HOTLINE FIX

Group: 54 – Chassis Electrical	**Original Date:** 13/08/2019	**No.** QE54-002
Model: QE Pajero Sport	**Subject:** SDA in call receiver echo/grammatical error in start message/bluetooth volume level.	
Revised on 12/09/2019 **Revised on** ..... (date) **Revised on** ..... (date)	Neil Dunn Head of Service Service Operations	Neil M Dunn
MMAL Ref P4487(C)	Document consists of 11 pages.

1. **Subject**: SDA in call receiver echo/grammatical error in start message/Bluetooth volume level.

Check the contents of the "Version Information".

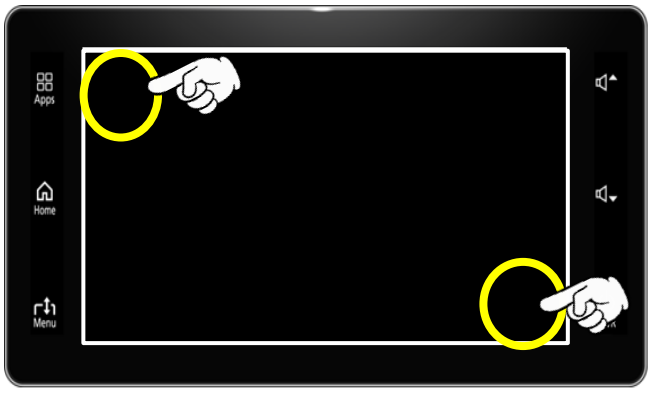
- If the latest software version is shown there is no need to update the software
- If the software version is not showing as the latest version, complete the software update.

New Software Version
2.3.0006.0200
